ANADROMOUS WATERS CATALOG/ATLAS CORRECTION FORM

CORRECTION TO:	ATLAS _	_x	CATALOGx	
REGION:SEA				
MAP: Sitka B-5				
WATERWAY NUMBER: 113-53-10020				
DESCRIBE CHANGE(S):	Changed	10020 to 100	30-2001to mate	ch NHD hydro.
CHANGE REQUESTED BY	:JJ	ohnson		2/9/2006 DATE
DRAFTEDDIGITIZED BY	:CB	arnhill		2/9/2006_ DATE
REVISION CODE:	C-1			
NOMINATION NUMBER:	0	5-590		
** ATTACH THIS	FORM TO E	XISTING NOMIN	JATION FORM IN	1 FILE **
(Rev. 11/93)

To: Subject: j_johnson@fishgame.state.ak.us Re: questionable hydrography

(See attached file: whitewater.jpg)

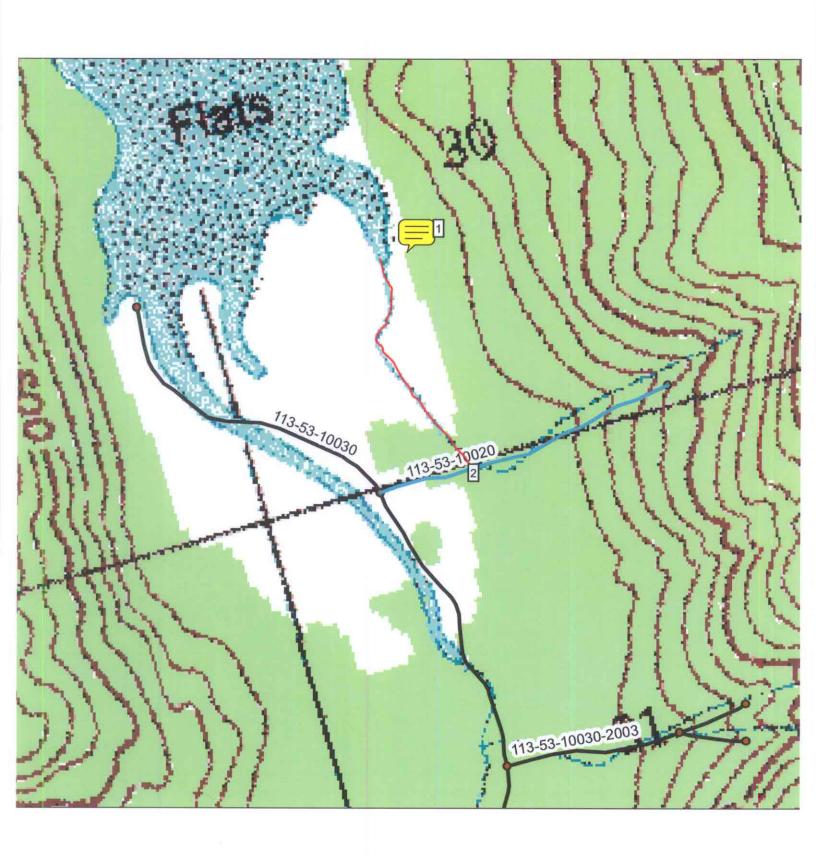
Mr. Johnson, the streams of the north watershed and the southern watershed are connected in the estuary via 'Unverified intertidal' (UI) and 'Unverified Connector' (UC) stream arcs, which are artifacts of the editing done to meet NHD routing requirements. I can see that the UC arc of the southeast stream network could have been digitized straight to the lowtide shoreline (pink line) without intersecting the north UI arc. I can make that edit in the Tongass hydrography but not in the NHD. Keeping the north separate from the south is consistent with our watershed boundary layer.
